E8363A-03

S E R V I C E N O T E

E8363A PNA Microwave Network Analyzers

Figure 1: A3 Front Panel Interface Board Assy without the Bracket

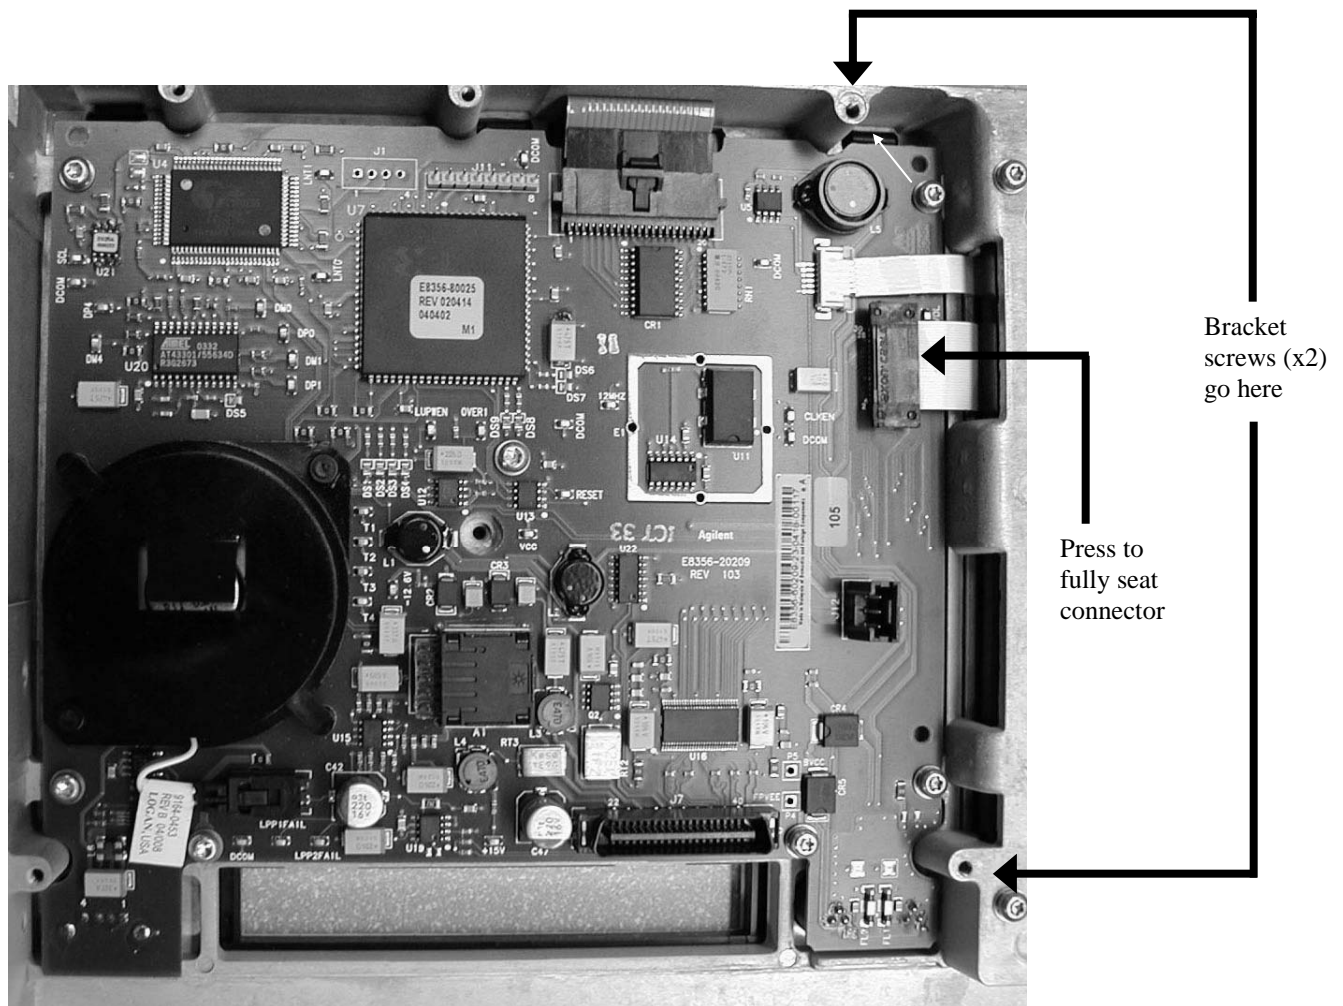
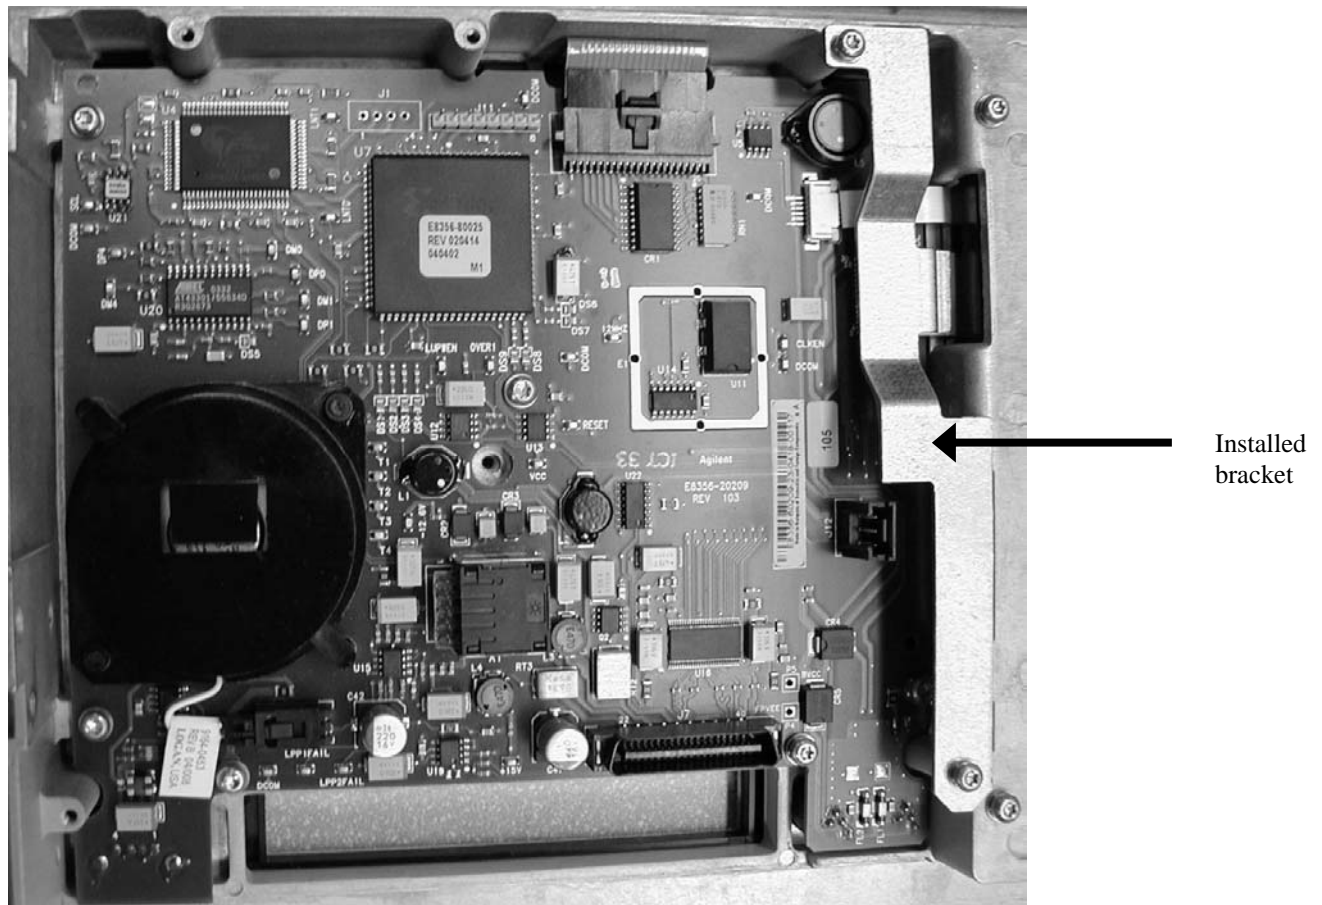
A connector of the ribbon cable (Agilent part number 8120-8409) that joins the front panel display to the front panel interface board can loosen, causing a display failure, unless a new bracket is installed. Because the failure rate has been very low, it is recommended that the bracket be installed only when there is an additional reason to remove the PNA front panel.

1. Refer to Figure 1 in this document:
 - Press down firmly on the ribbon cable's black connector.
 - Locate the two tapped holes for the bracket screws.
2. As shown in Figure 2 in this document, position the bracket so that its holes line-up with the two holes you located in the previous step.
3. Hand-start the two screws, and then torque both to 9 in-lbs.
4. Reinstall the PNA Front Panel by following the Service Guide instructions in the "Replacement Procedure." This is located on the same page as the "Removal Procedure" used previously in step 7.
